CHELAN COUNTY NATURAL RESOURCE DEPARTMENT  
ICICLE CREEK STREAMBANK RESTORATION-RM 1.0

**ADDENDUM NO. 2**

**1. Revised Final Plans Set with Corrections to LWM Structure Log Schedule's**

- ALL LOGS WILL BE DOUGLAS FIR, PONDEROSA PINE, OR WESTERN RED CEDAR TREES.
- LOGS WITH ROOTWADS SHALL HAVE A DIAMETER AS SHOWN MEASURED AT DBH, DEFINED AS 4.5 FEET ABOVE GROUND WHEN THE TREE WAS STANDING.

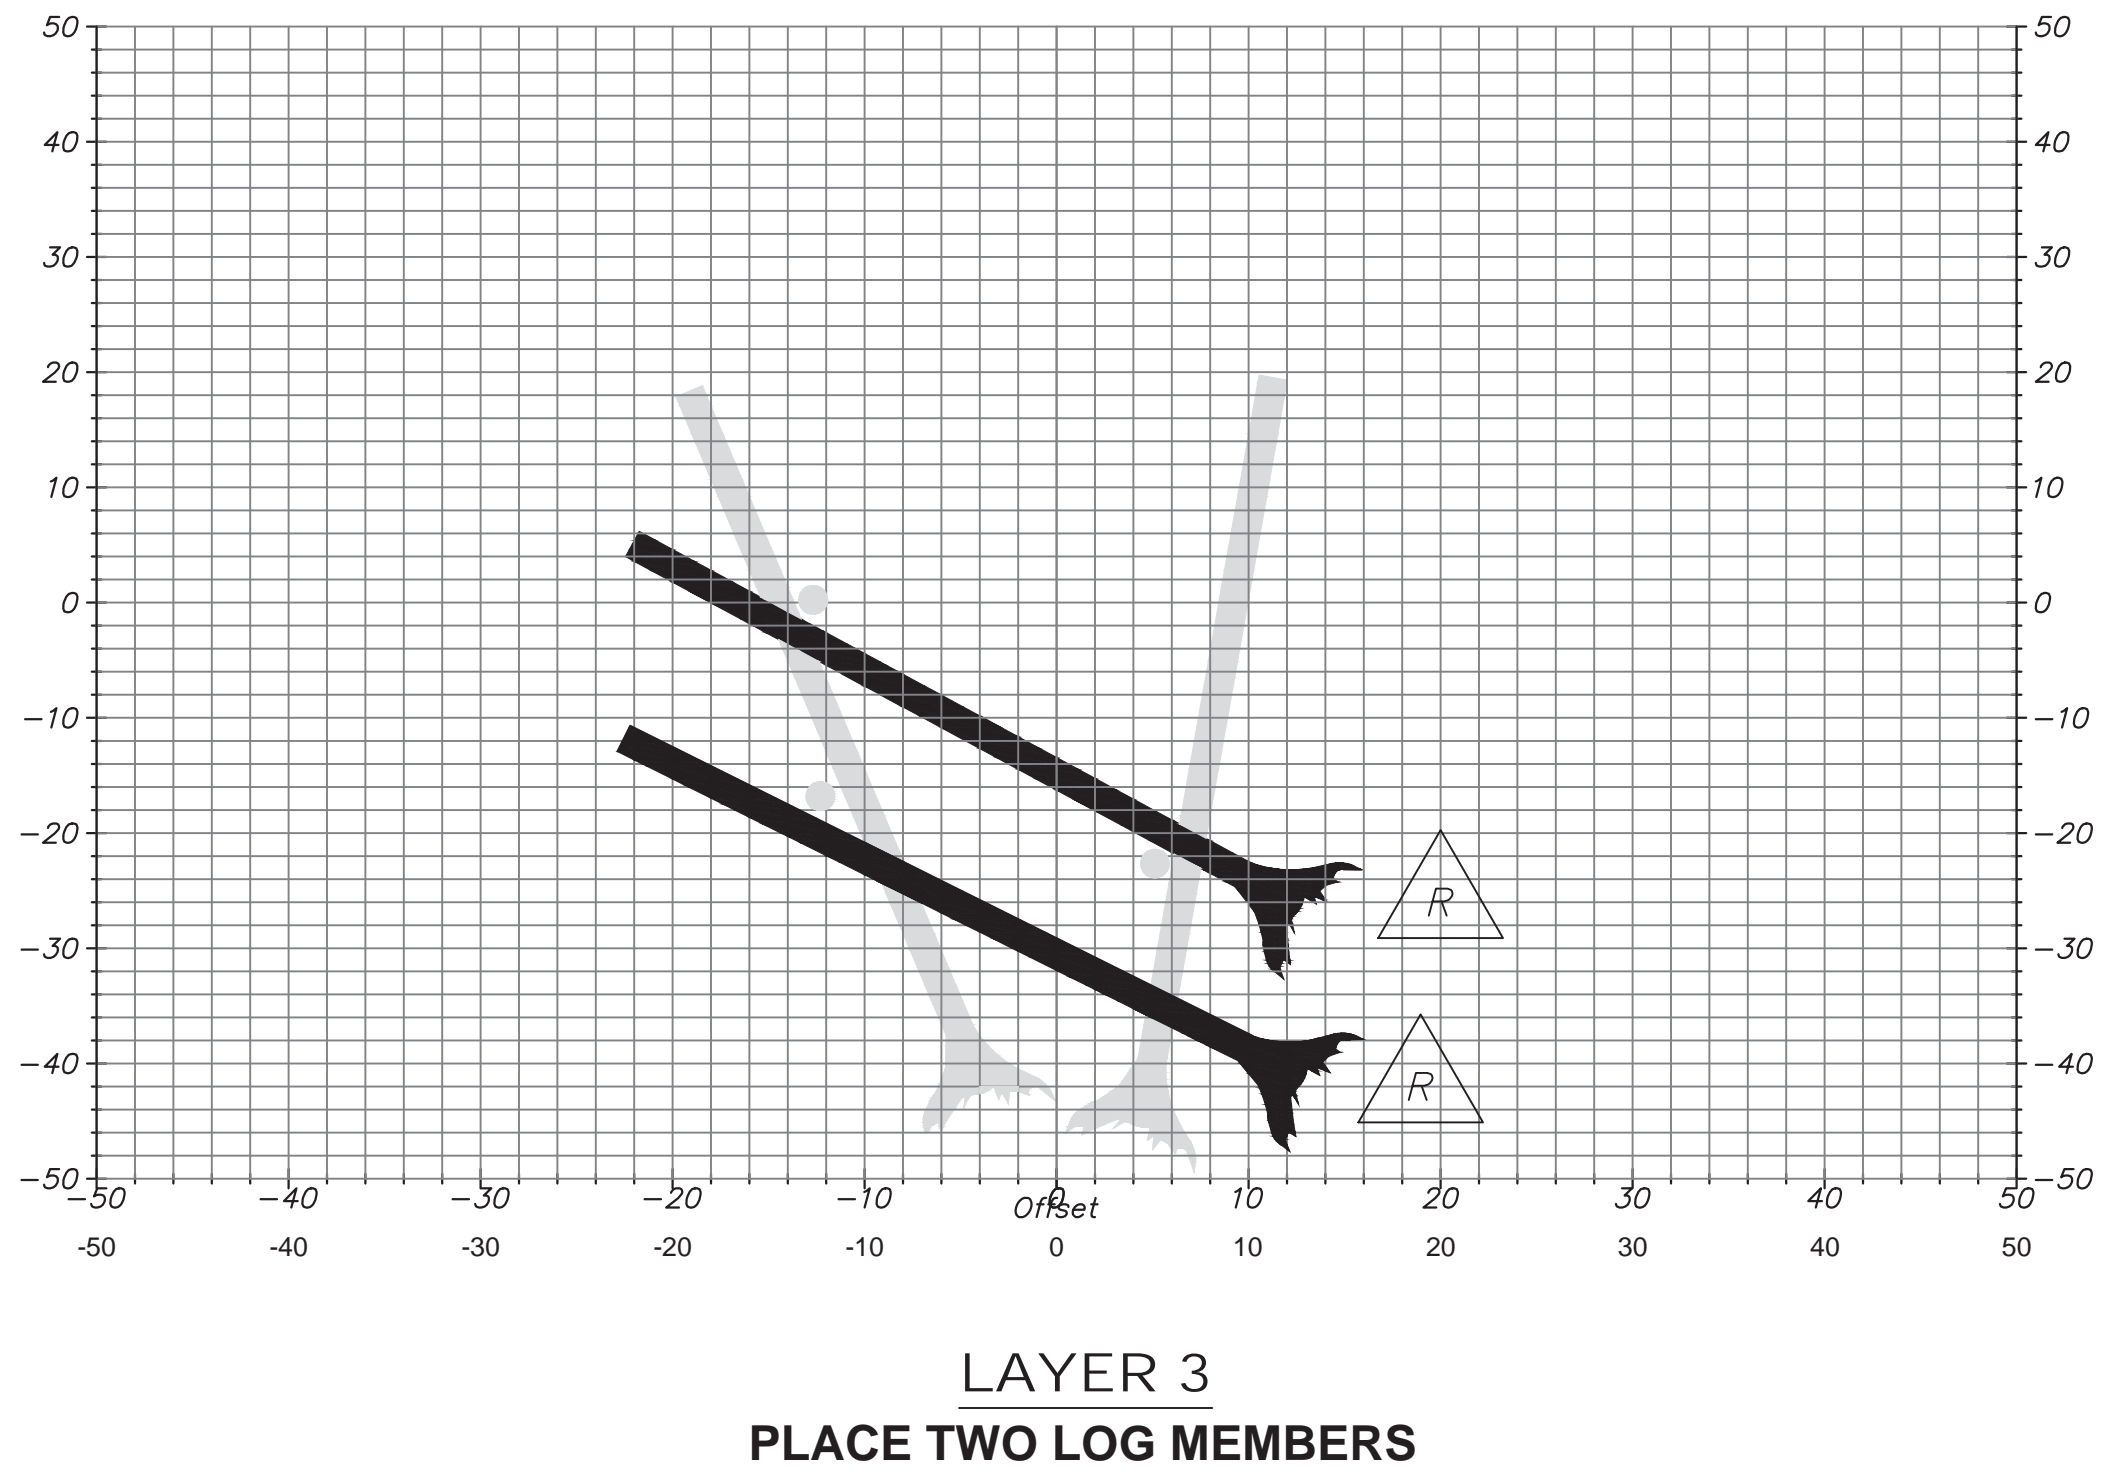
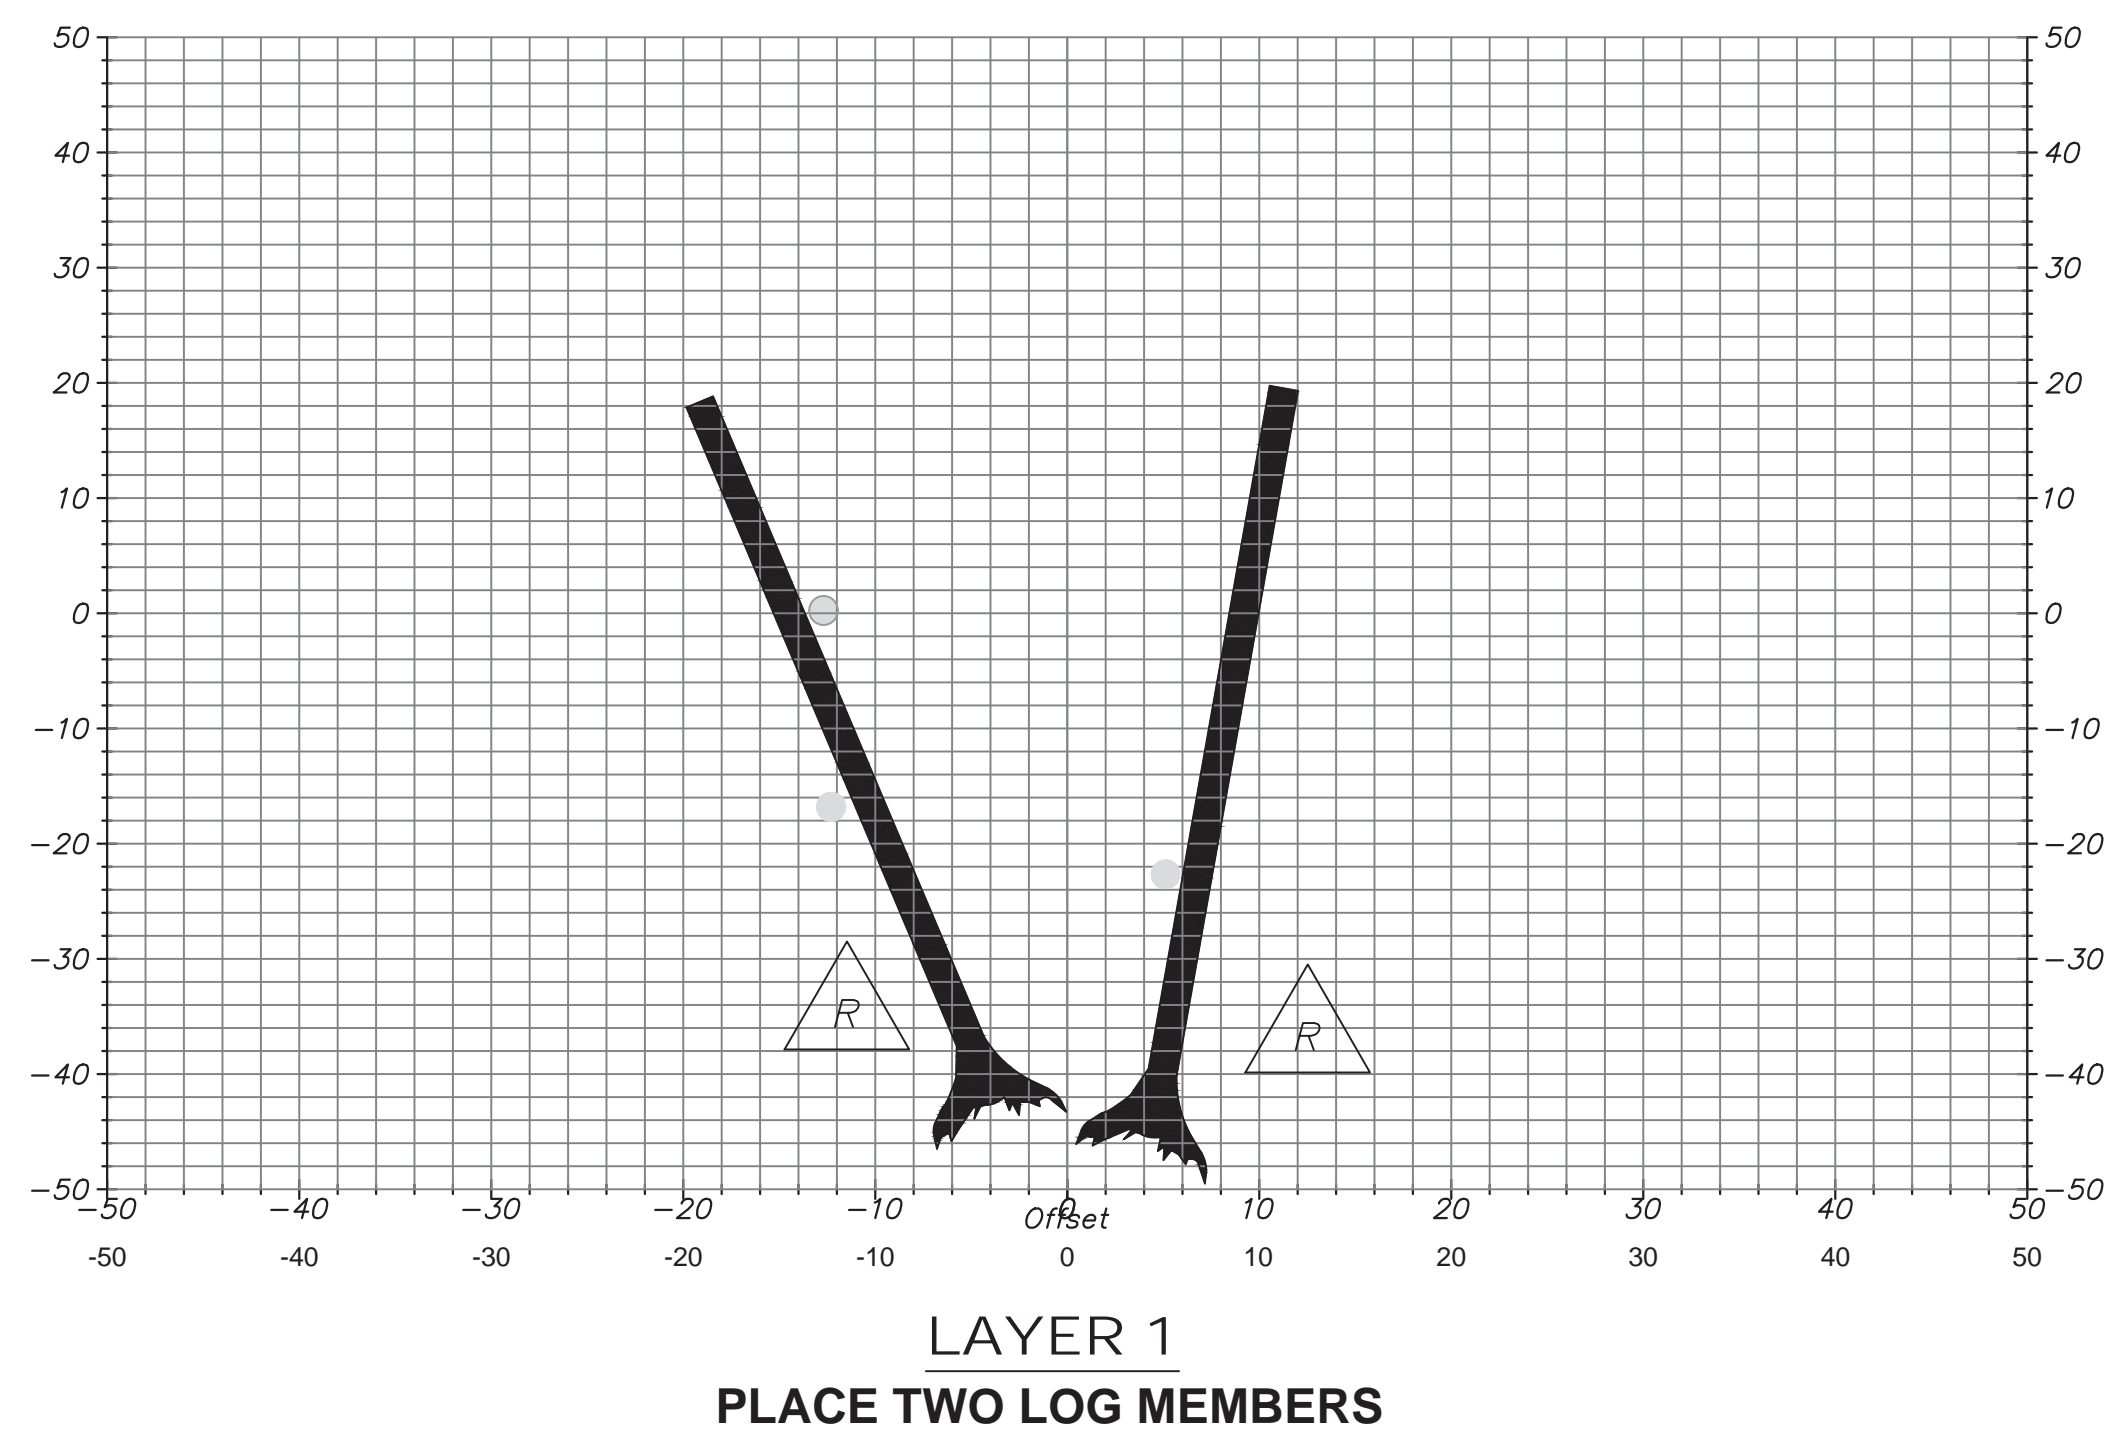
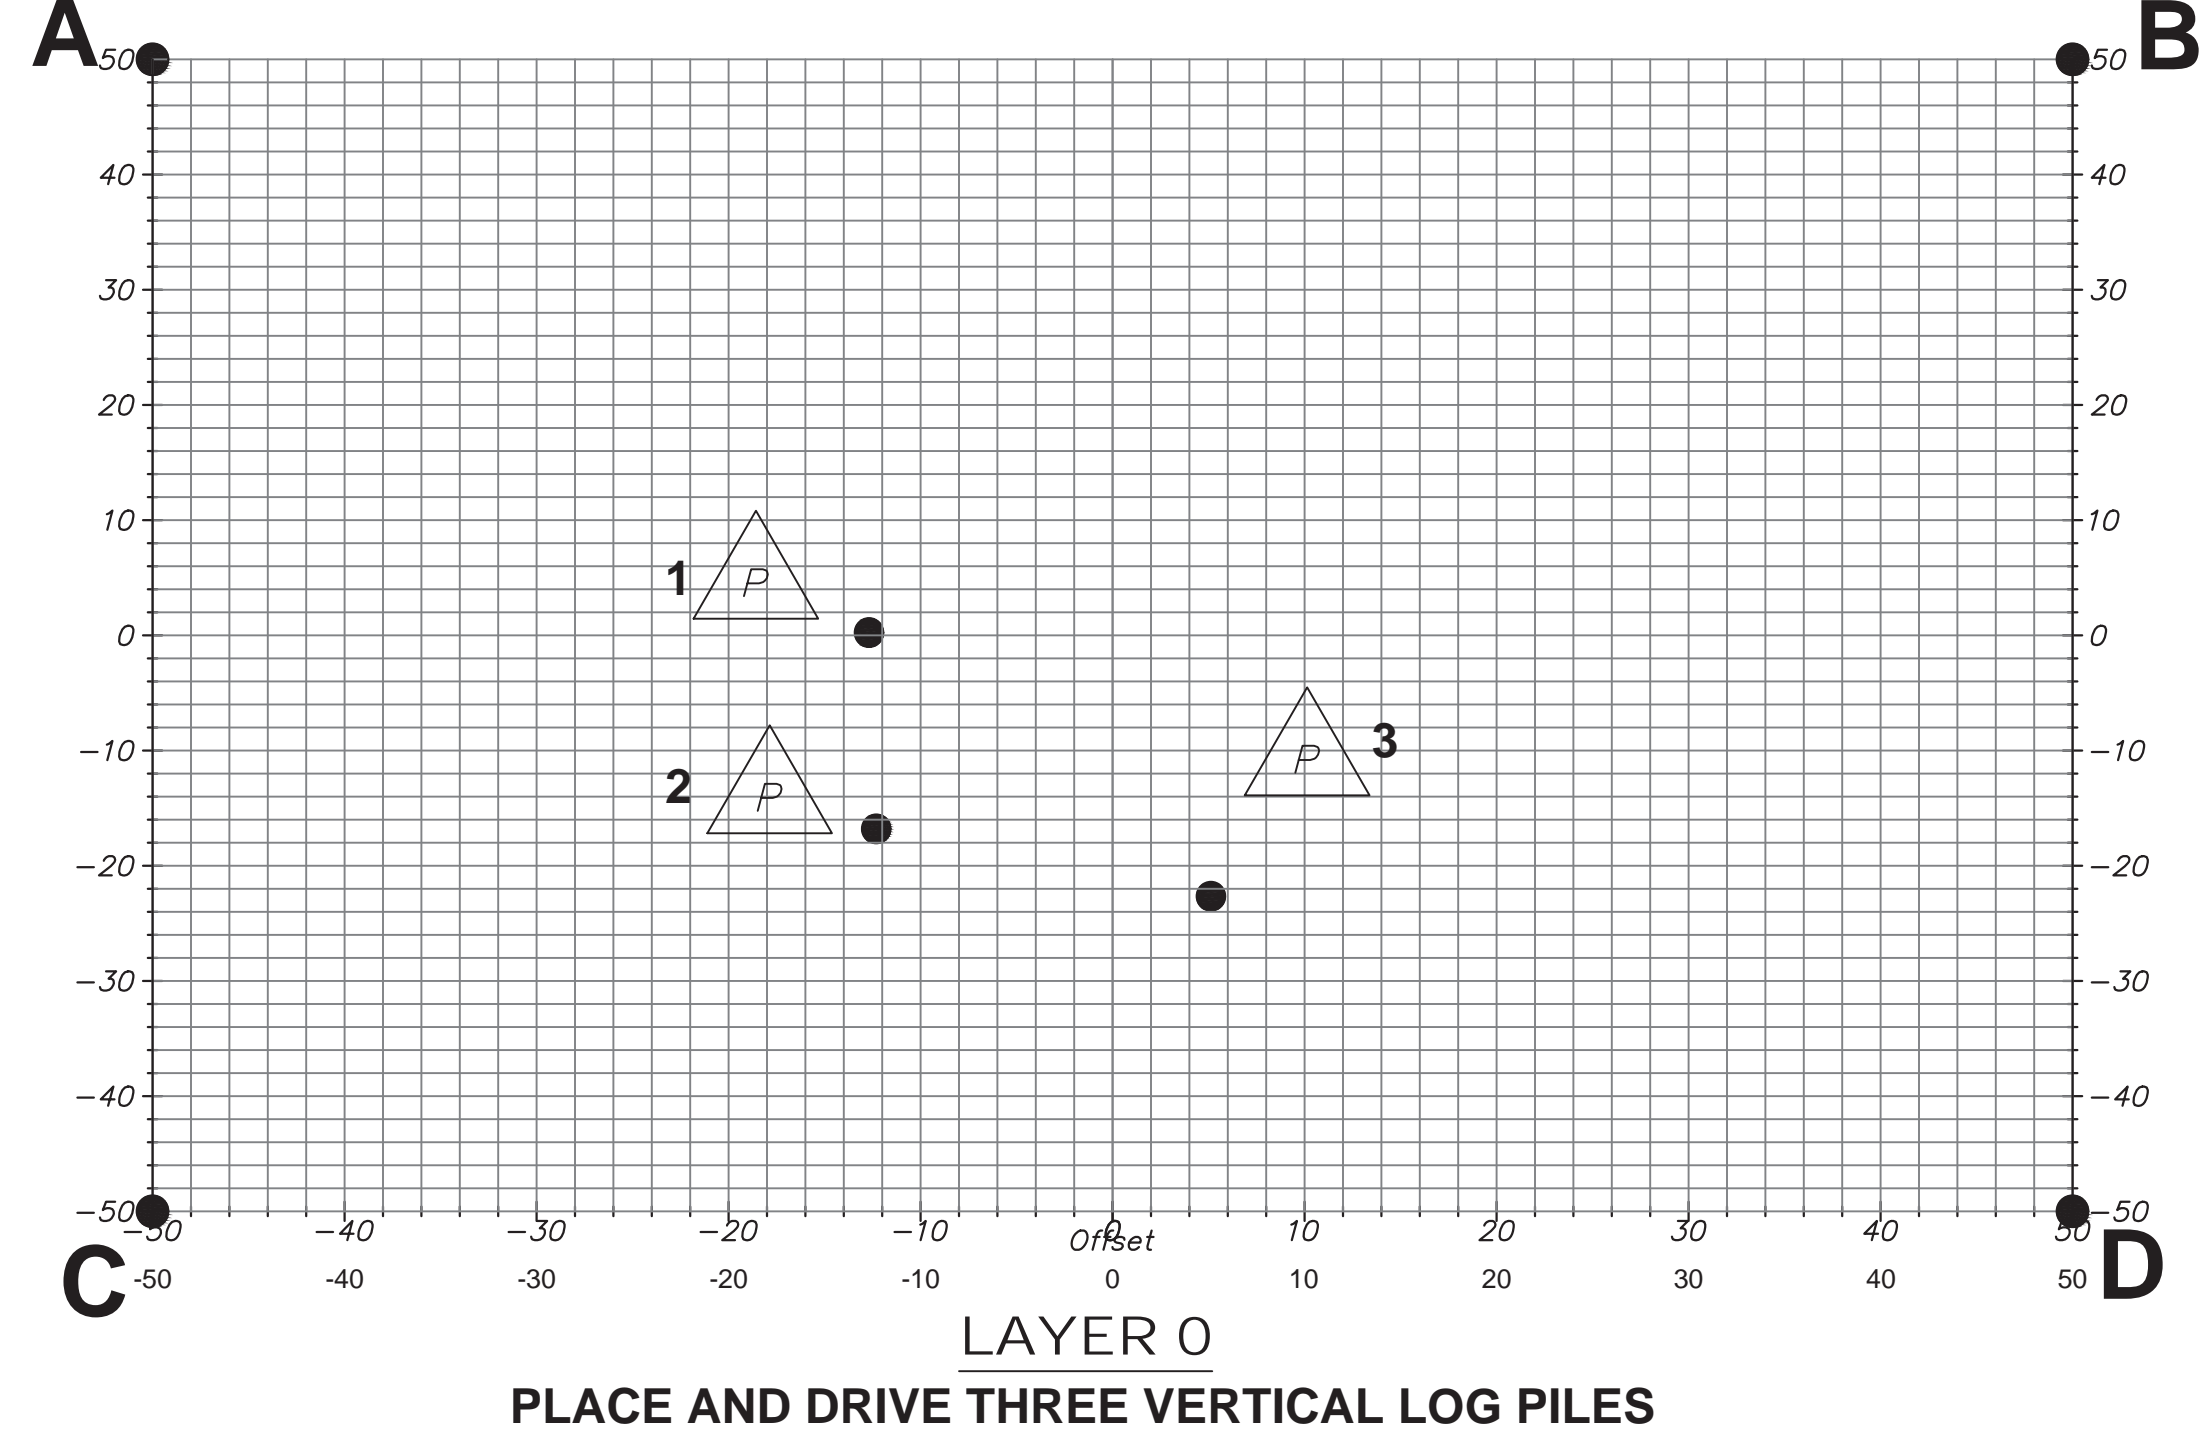
The "LWM Structure Log Schedule" on both sheets 9 (Type 1 LWM Structure) and 12 (Type 2 LWM Structure) have been corrected to show a pile length of 25' and dbh of 12"-15" as indicated in section 8-26.2(1) of the special provisions. The updated plans provided with this addendum are considered the new Final Plan set for this project.

DATE:	3/4/22	BY:	OK
NO.:	1	REVISION:	SS
3/4/22 corrected pile log diameter and length

LOG ID	COLOR	DIA. (INCHES)	LENGTH (FEET)	ROOTWAD (Y/N)	QUANTITIES PER STRUCTURE	NOTES
R	Blue	18	40	Y	4	
P	Red	18- 12 to 15	40 25	N	5
